SURRY POWER STATION, UNIT NO. 2

AMENDMENT TO FACILITY OPERATING LICENSE

Amendment No. 59
License No. DPR-37

ATTACHMENT TO LICENSE AMENDMENT NO. 59

MAXIMUM ALLOWABLE AIR PARTIAL PRESSURE
SURRY POWER STATION - UNIT NO. 2

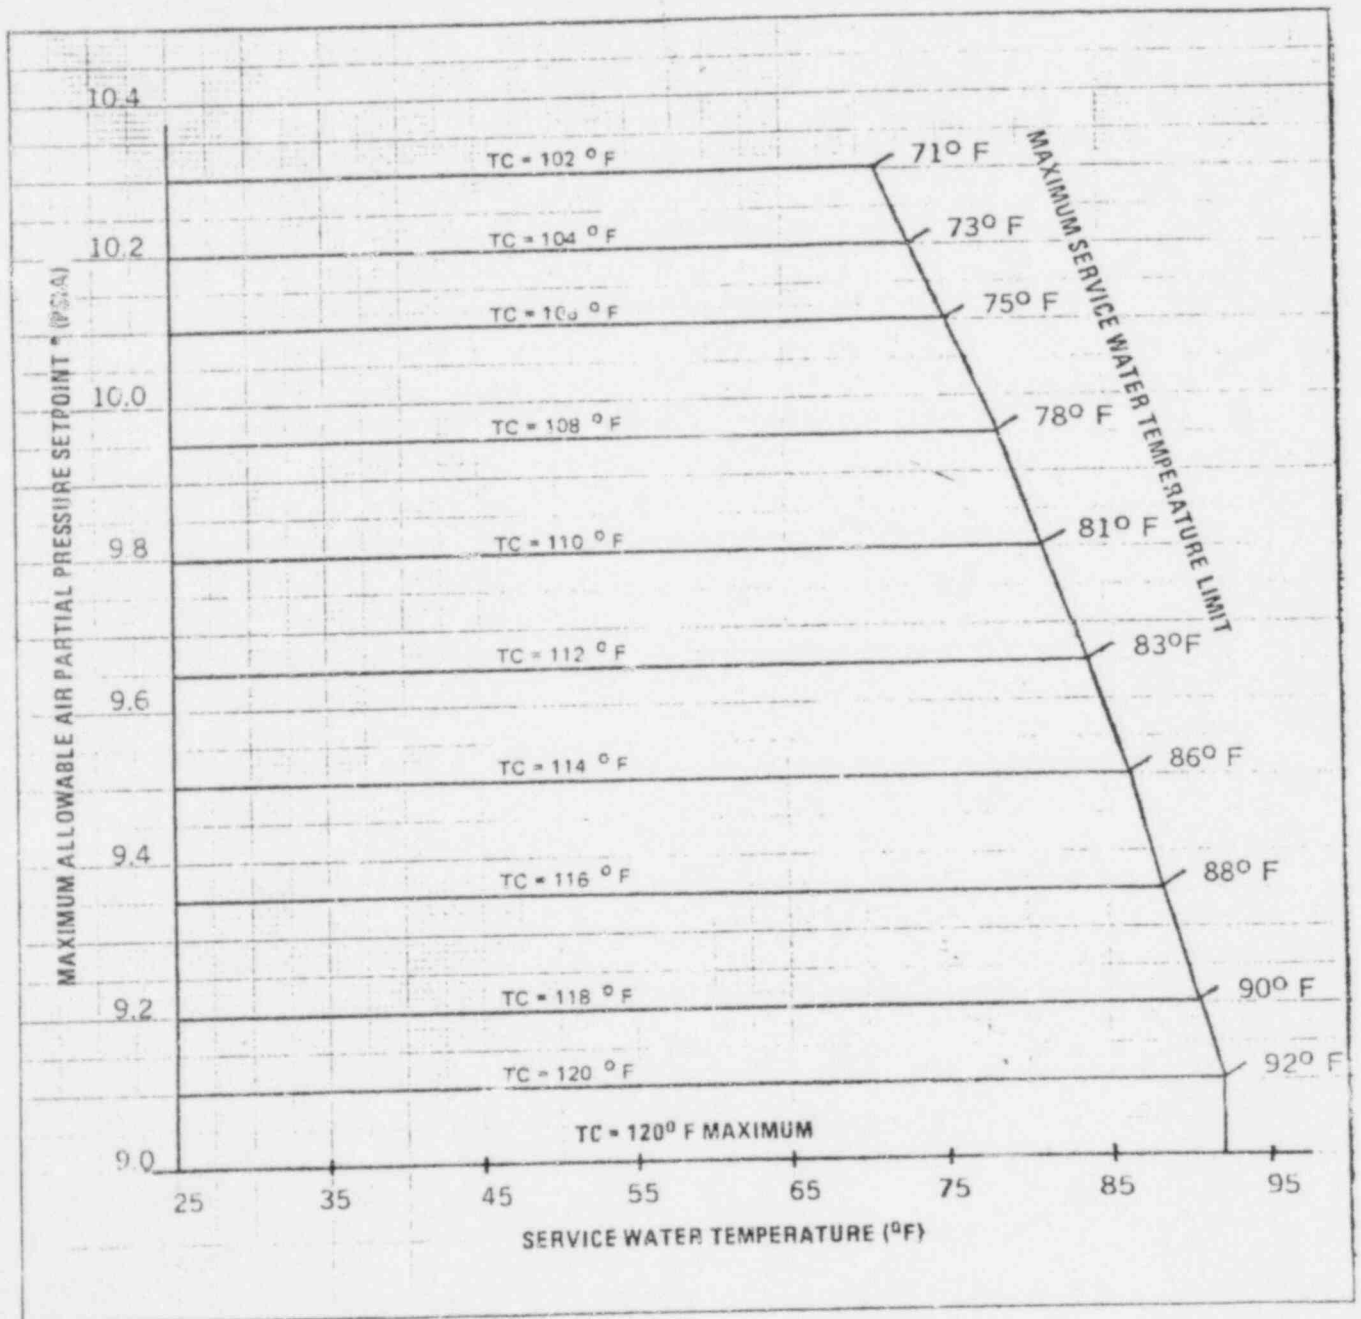
The maximum allowable set point for the containment air partial pressure is presented in Figure 3.8.2-1 for service water temperature from 25 to 90°F. The allowable set point varies as shown in Figure 3.8.2-1 for a given containment average temperature. The RWST water shall have a maximum temperature of 45°F.

The horizontal limit lines in Figure 3.8.2-1 are based on LOCA peak calculated pressure criteria, and the sloped line is based on LOCA subatmospheric peak pressure criteria.

The horizontal limit line designates the maximum air partial pressure set point for the given average containment temperature. The horizontal limit line applies for service water temperatures from 25°F to the sloped line intersection value (maximum service water temperature).

From Figure 3.8.2-1, if the containment average temperature is 112°F and the service water temperature is less than or equal to 83°F, the air partial pressure set point value shall be less than or equal to 9.65 psia. If the average containment temperature is 116°F and the service water temperature is less than or equal to 88°F, the air partial pressure set point value shall be less than or equal to 9.35 psia. These horizontal limit lines are a result of the higher allowable initial containment average temperatures and the analysis of the pump suction break.
